ADDENDUM NO. 2

Reference: Training Housing – Division of Services for the Blind and Visually Impaired
Utah State Office of Rehabilitation – Salt Lake City, Utah
DFCM Project No. 09240200

STAGE TWO
ADDENDUM NO. 2

Utah State Office of Rehabilitation
Services for the Blind and Visually Impaired
Training Housing
1991 & 1995 W 400 North
Salt Lake City, Utah 84116

SHEET NUMBER
LE-503

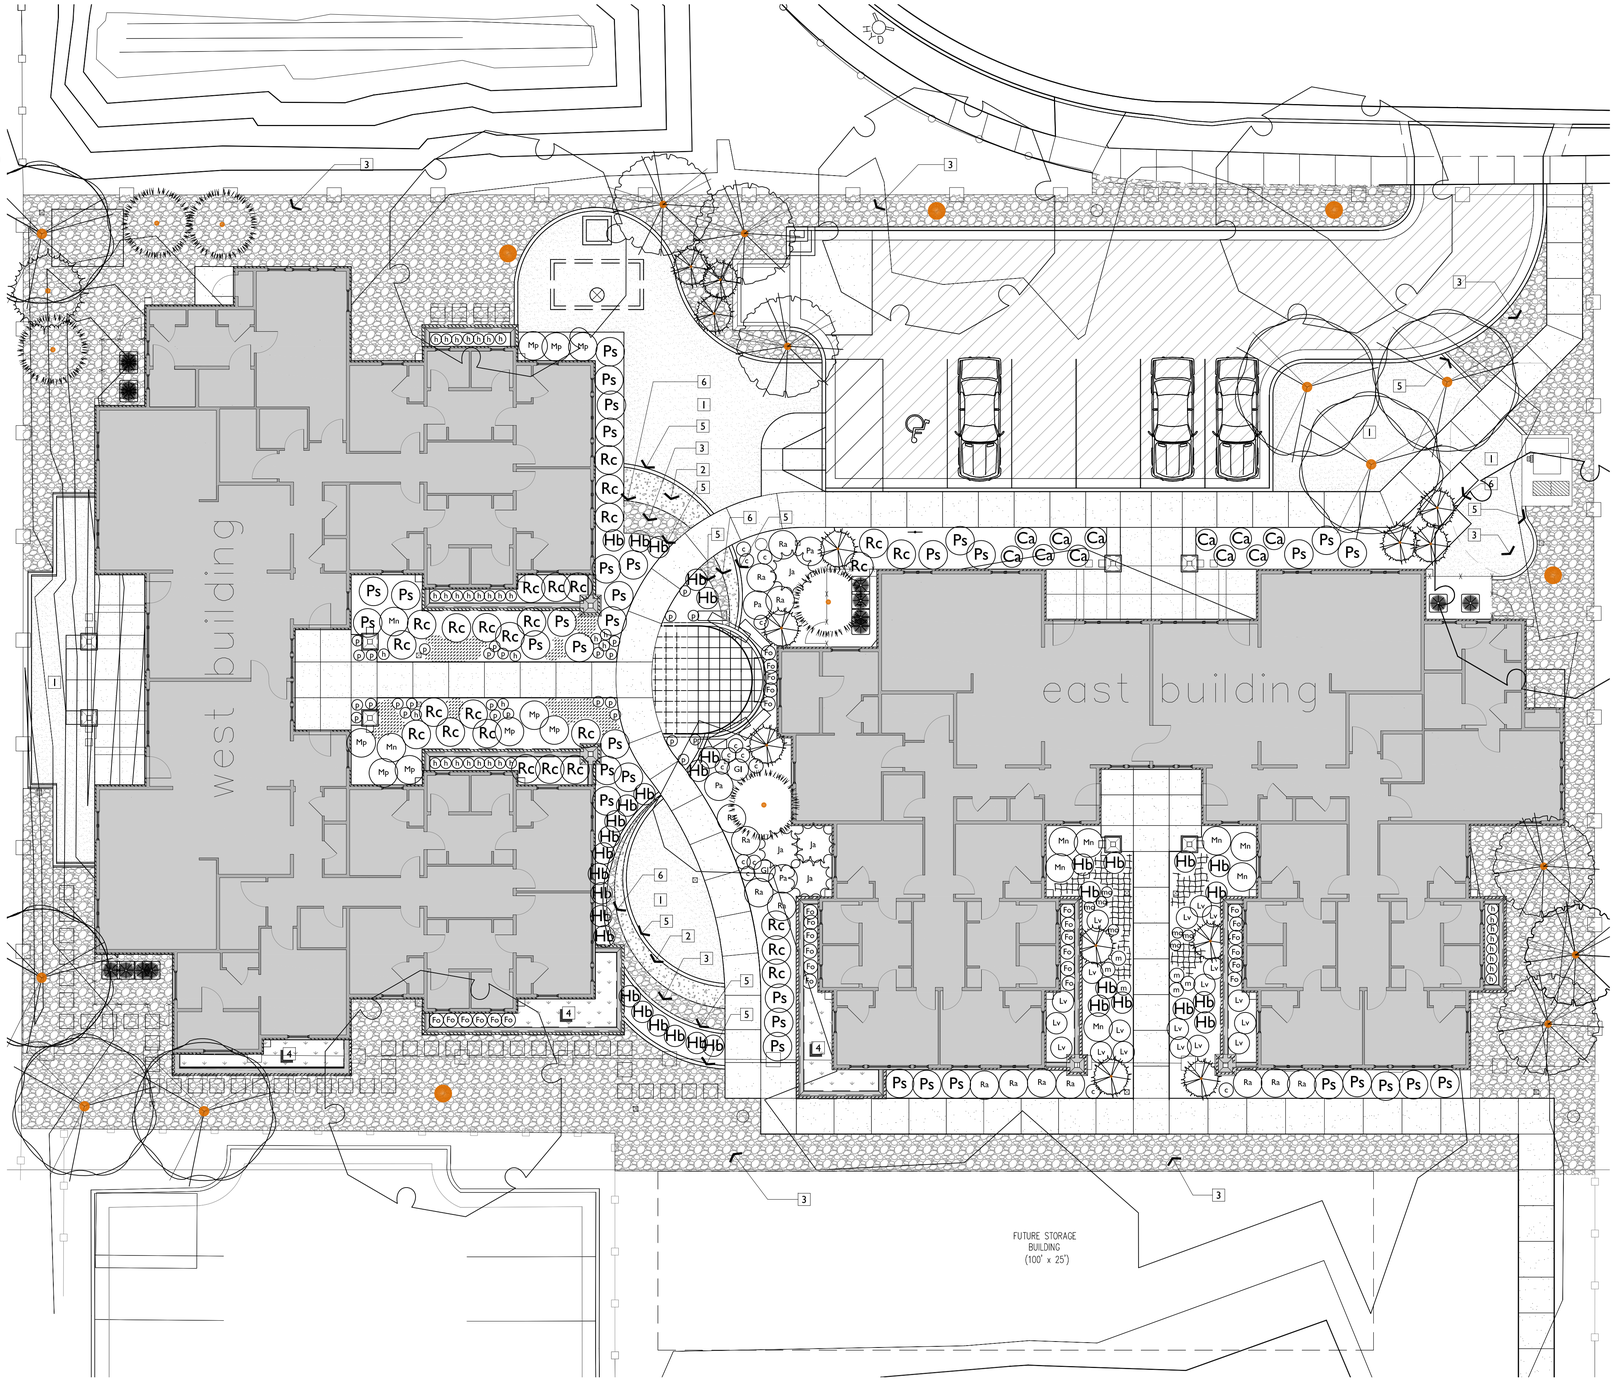
1. Sheet Number changed to LE-503.
2. Detail 8 added.

SHEET NUMBER
SB-501

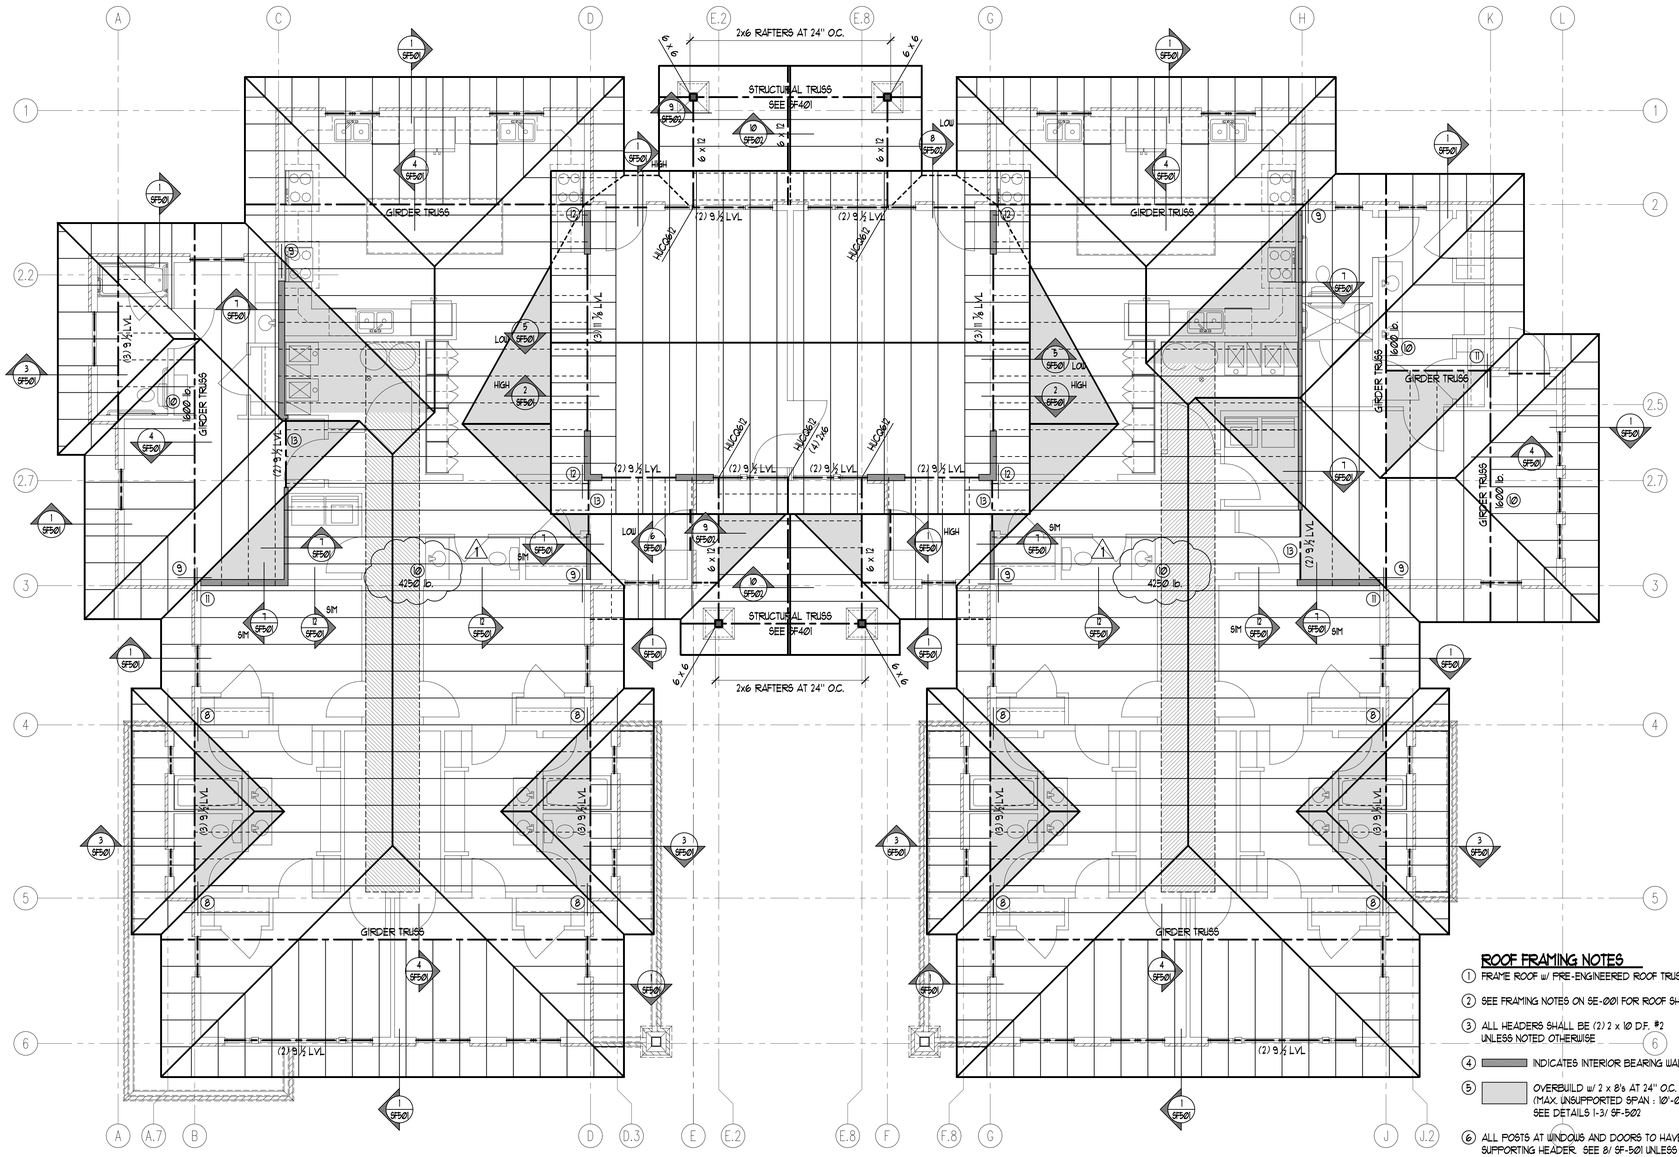
1. Revisions to details 1, 4, 5, 6, 7, 8, and 10.
2. Construction detail 11 – not used.

Item 04-12: Bidding Question #12 – "QUESTION: Do all the exterior building foundations recess for the building wall like shown on detail 2/AE-303. This is not shown on details 1/AE-303 and 1/AE-302? All the structural details on SB-501 do not show any recess at all." **Answer: Yes, provide the exterior building foundation recess for the building throughout. See revised details 1/SB-501 & 8/SB-501.**

AE-102

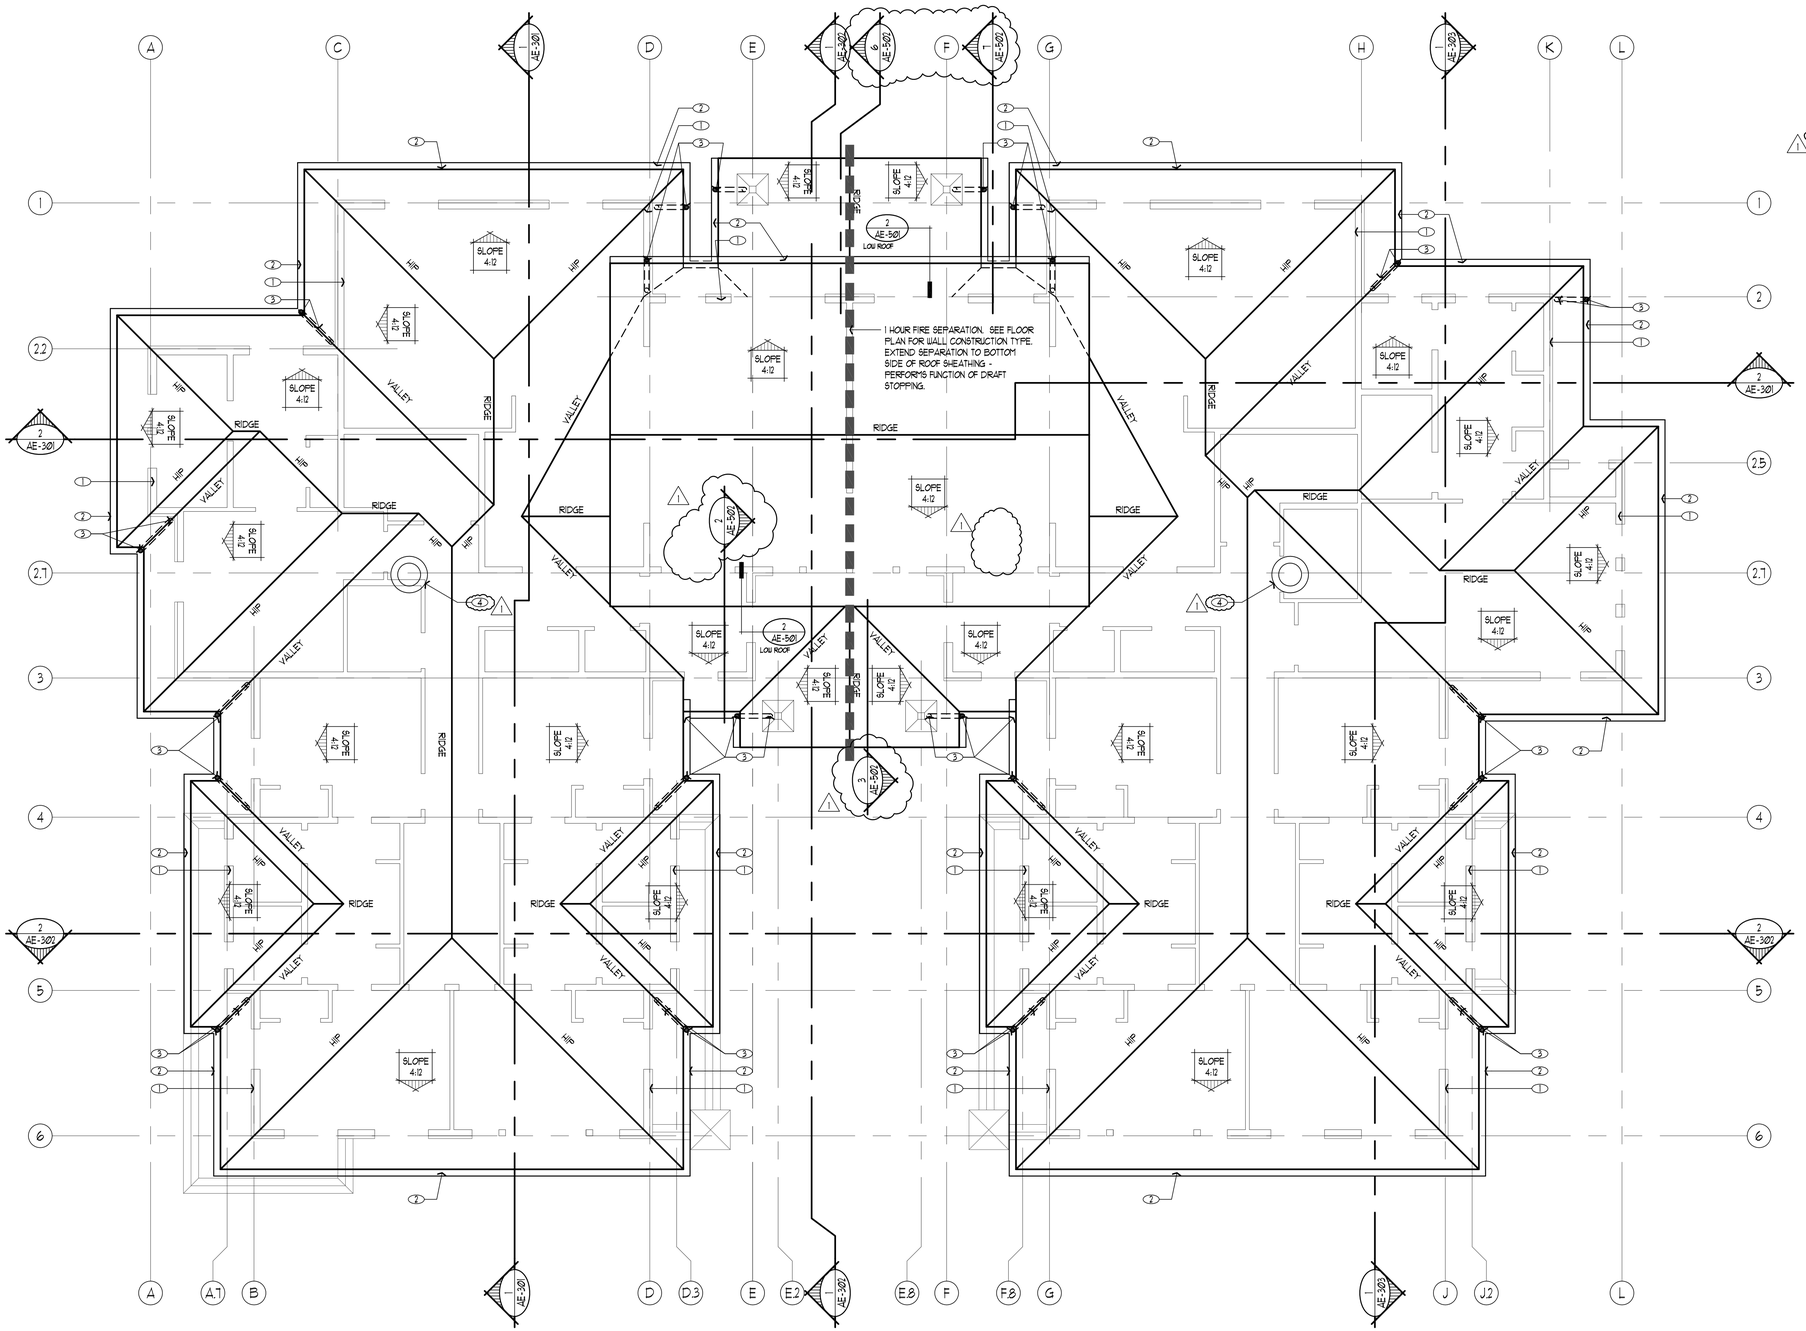
1. Added window designations, including tempered and obscure locations.
2. Revised Sheet Note 6: "Arched ceiling transition header – see building sections & reflected ceiling plan" and added sheet note reference to plan.
3. Added Sheet Note 12: "2-A-10B:C Fire Extinguisher & Semi-recessed fire extinguisher w/ lock – see detail 22/AE-503" and located cabinets on the plan.
4. Added Sheet Note 13: "Column Base – see sheet AE-502" and placed sheet note reference on the plan.
5. Deleted 2nd water heater in Mech (125) and Mech (157) to match mechanical drawings.
6. Added building section references between grid lines E & G, above grid line 1 and between grid lines D & E.8, and between grid lines 3 & 4.

AE-103

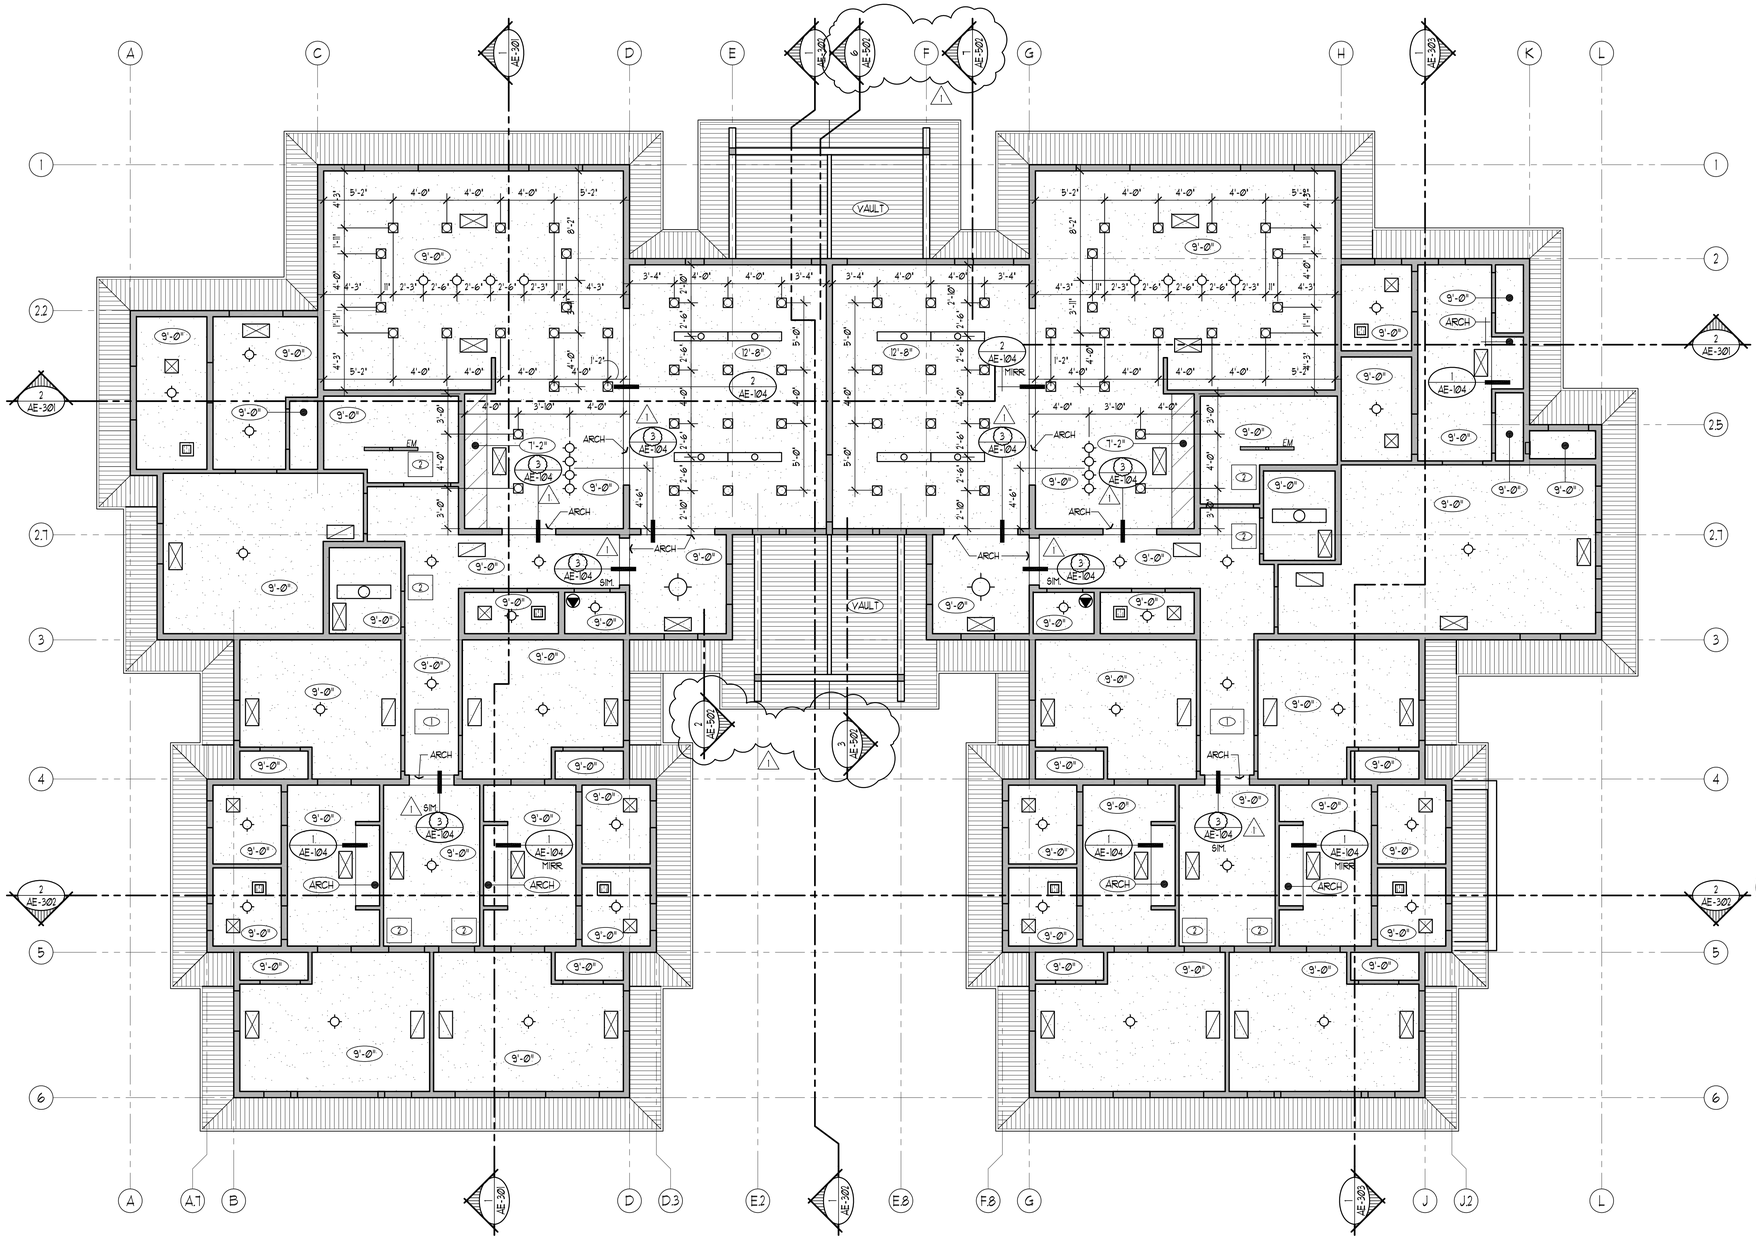
1. Deleted sloping requirement at Sheet Note 2.
2. Added Sheet Note 4: "Roof ventilator – see details 11 & 12/AE-501 and mechanical drawings" and placed ventilators on roof drainage plan.
3. Eliminated gutters and downspouts along high roof eave line (between grids 2.7 & 3).
4. Added building section reference between grid lines E & G, above grid line 1 and between grid lines D & E.8 and grid lines 3 &4.

AE-104

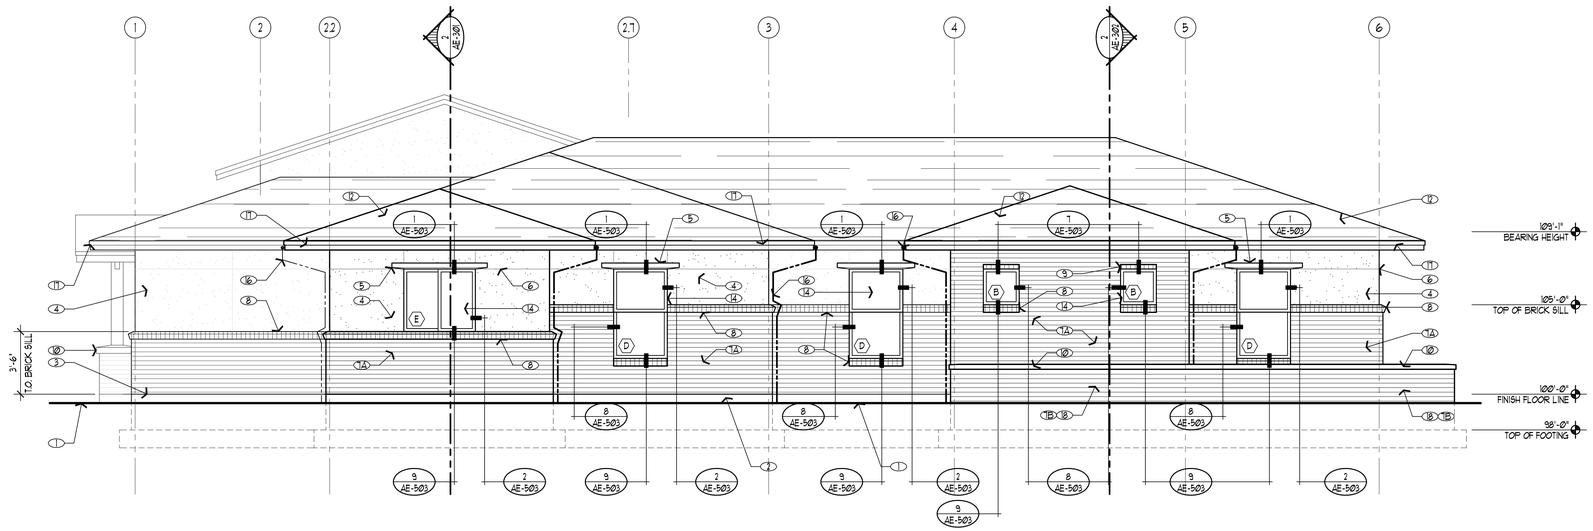
1. Added building section reference between grid lines E & G, above grid line 1 and between grid lines D & E.8 and grid lines 3 &4.
2. Revised details 1 & 2 and added detail 3.
3. Added "paint to match finish ceiling" to sheet notes 1 & 2.
4. Updated detail references at arches.

AE-301

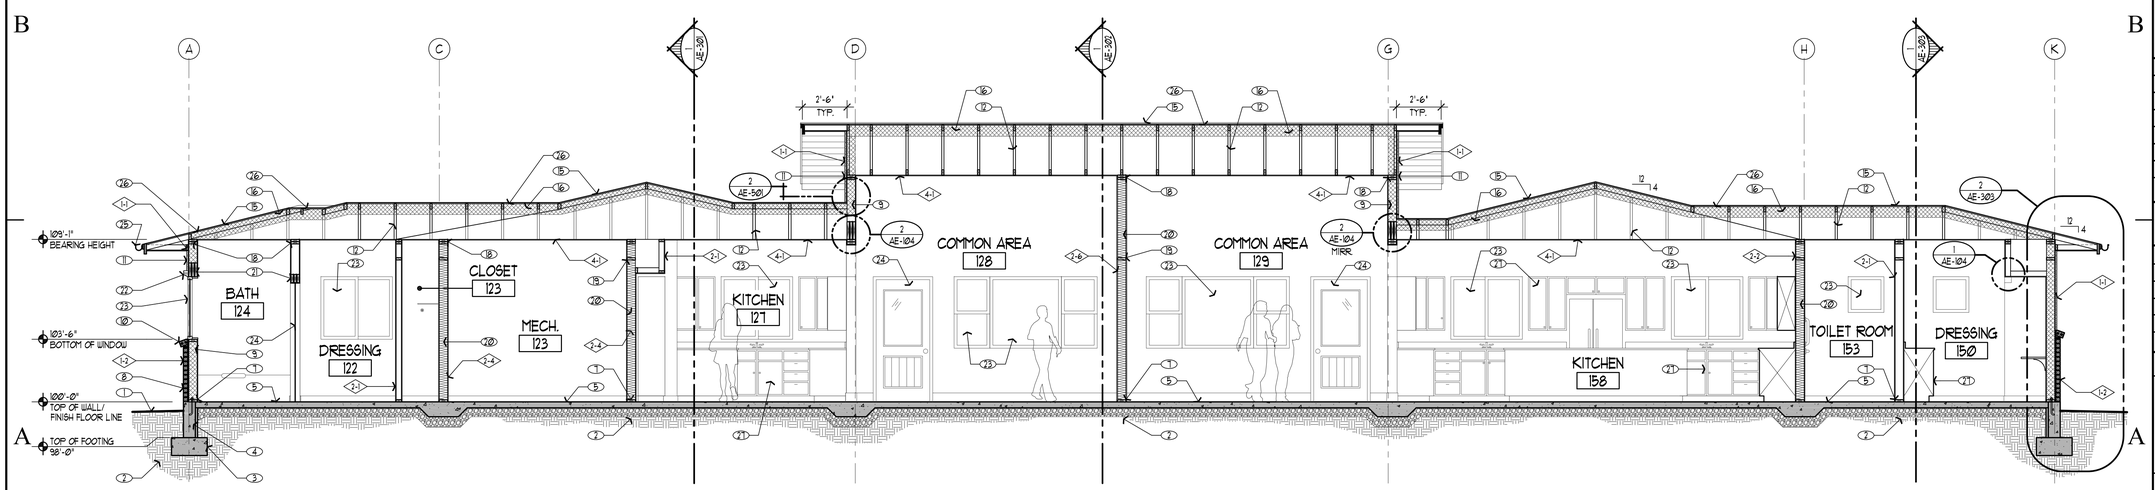
1. Revised Sheet Note 28 to reference detail 8/AE-501.
